Title: **Stage 1 Road Safety Audit**

**Proposed Residential Development, Cairnbrook,
Glenamuck Road, Carrickmines, Co. Dublin.**

Report reference: **1544R01**

VERSION: **FINAL (29-7-2022)**

3.1 Problem

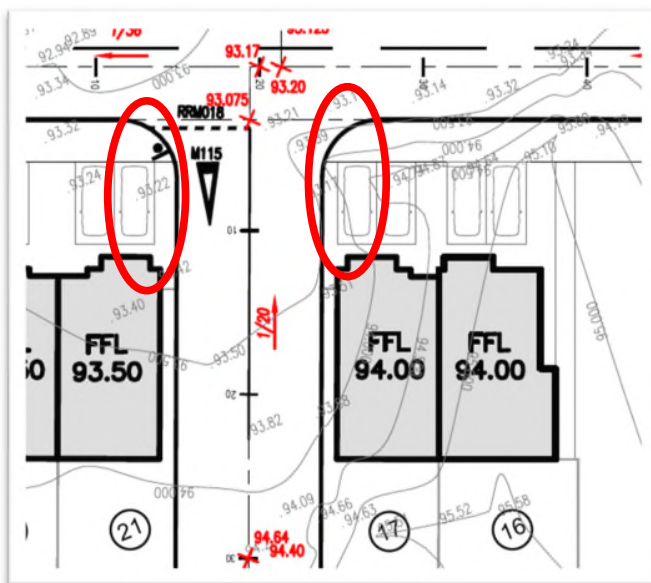
The parking spaces at units 21 & 17 are very close to the internal junction. Drivers reversing out of these spaces may not be able to check for traffic approaching from all directions which could lead to collisions.

It is recommended that the spaces be kept further away from the junction.

3.1	Y	N	Layout has been amended to shared area to address this matter	Yes
3.2	Y	N	Layout has been amended to a homezone to address this matter	Yes
3.3	Y	N	Layout has been amended to a homezone to address this matter	Yes

3.2 Problem

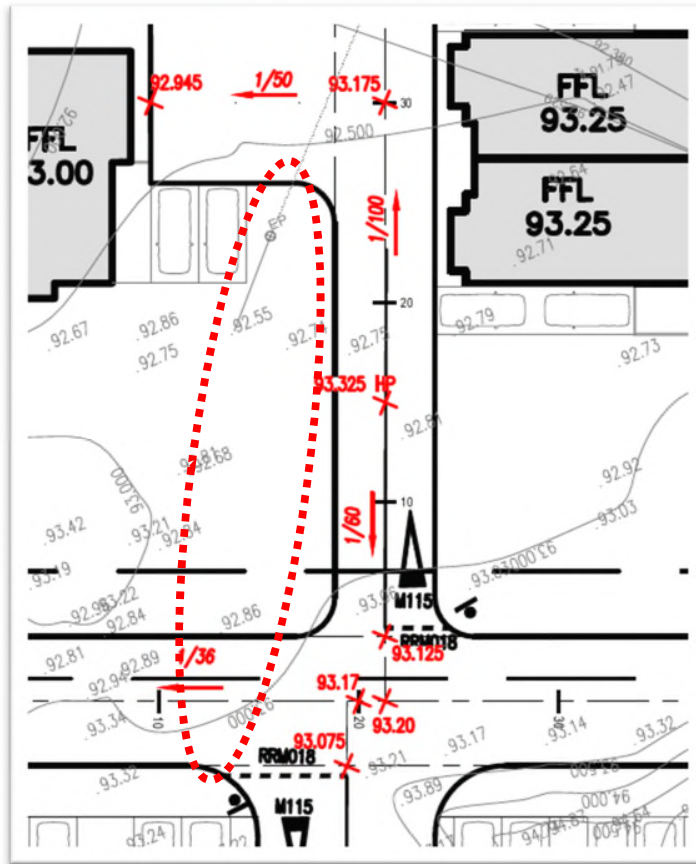
There are no footpaths shown connecting to units 22, 23 & 24. This could lead to pedestrians colliding with turning vehicles or walking across the green area resulting in slips and falls.

It is recommended that a footpath be provided linking to the main footpath network with crossing points or that a shared use Street be provided with a transition zone for pedestrians to join the footpath network at the interface with the non-shared street.

3.3 Problem

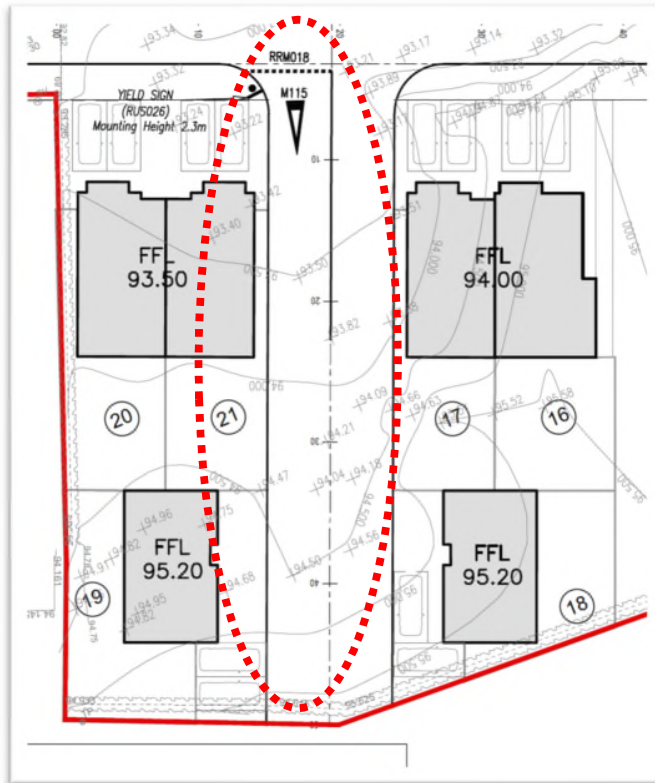
There are no footpaths shown connecting to units 16 to 21. This could lead to pedestrians colliding with passing vehicles.

It is recommended that a footpath be provided linking to the main footpath network with crossing points or that a shared use Street be provided with a transition zone for pedestrians to join the footpath network at the interface with the non-shared street.

3.4 Problem

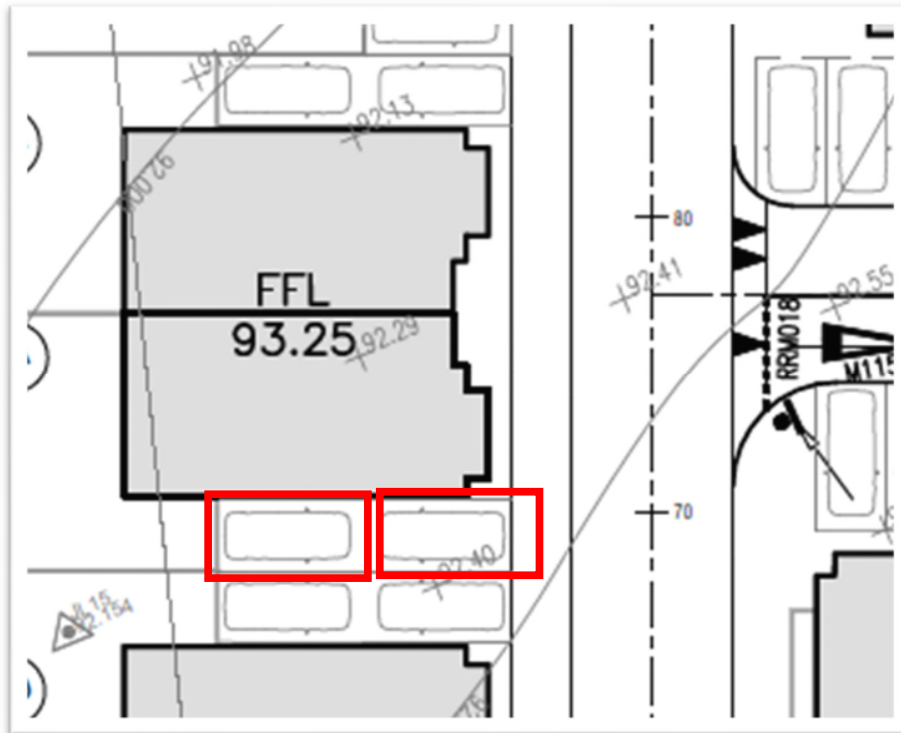
It is proposed to have stacked parking at some units. Residents may park their vehicles on the footpath to avoid having to move vehicles to let others out. Parked vehicles on the footpath are hazards for pedestrians especially the mobility impaired, blind or partially sighted.

It is recommended that the stacked parking be removed.

3.4	Partially	N	In order to obtain the required density and ensure effective land use stacked parking has been provided	Yes
3.5	Partially	N	The area in question is a homezone	Yes

3.5 Problem

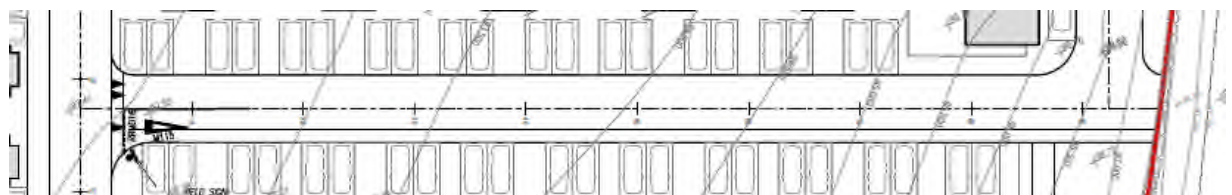
There are no footpaths along the side roads off the main internal access road. It may be intended that these roads will be shared use streets. It appears however that these streets will be extended in the future and may contain excessive traffic or even through traffic which would not be suitable as a shared street.

It is recommended that footpaths be provided should future extensions be possible.
